# Camden Residents' Action Group Incorporated Camden – Still a Country Town

Re: Second CRAG submission 2-4 John Street, Camden DA s4.56 Modification: 2008/644/51

Consolidation of buildings 3 and 5 into one building, conversion of 26 multiple-unit dwellings into 26 self-contained seniors living dwellings, conversion of 2 shops into 2 self-contained seniors living dwellings, internal layout reconfiguration to provide 2 additional self-contained seniors living dwellings, reconfiguration of the lower ground floor car park underneath buildings 3, 4, 5 and 6 and replacement of a turning circle with a pedestrian path

Source: Benson McCormack Architecture

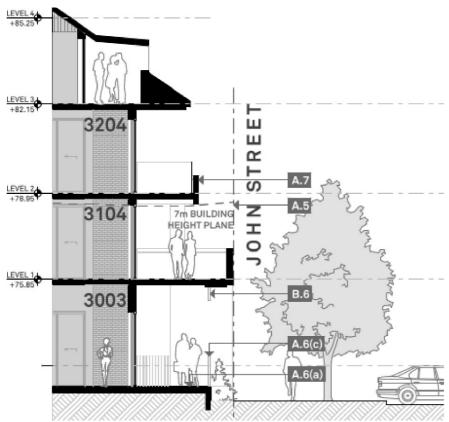
However, it has now been confirmed to us that the proposed John Street setbacks for the modified buildings 3 and 5, will range from approximately 3.48m - 3.5m to the <u>main building</u> <u>façade line</u> at the ground, first and second floor levels, with the second-level balcony having no setback and the third-floor level having the largest setback as depicted below.

This means that that verandas are very close to the site boundary. We cannot understand why any resident would want their personal space to be so close to or on the boundary of a public footpath. This will surely devalue the apartments as well as the streetscape.

There is no practical discernible setback from John Street, and little room for landscaping which is of paramount importance to accommodating such over-height, over-scale and bulky urban style structures within the HCA.

From our reading we conclude that the proposed setbacks are not compliant with any planning controls. For instance:

Camden DCP 2019 (4.6) Multi-dwelling Housing indicates a minimum setback of 4.5m.

If this development was subject to the NSW Complying Development Code<sup>6</sup> a 10m setback would be required.

The proposed setback to John Street does none of the above.

The buildings 3 and 5 should not be combined and enlarged to become more imposing and anomalous in the historic development pattern of the town. The two buildings must be set back and effectively landscaped to soften their impact and integrate appropriately into the HCA.
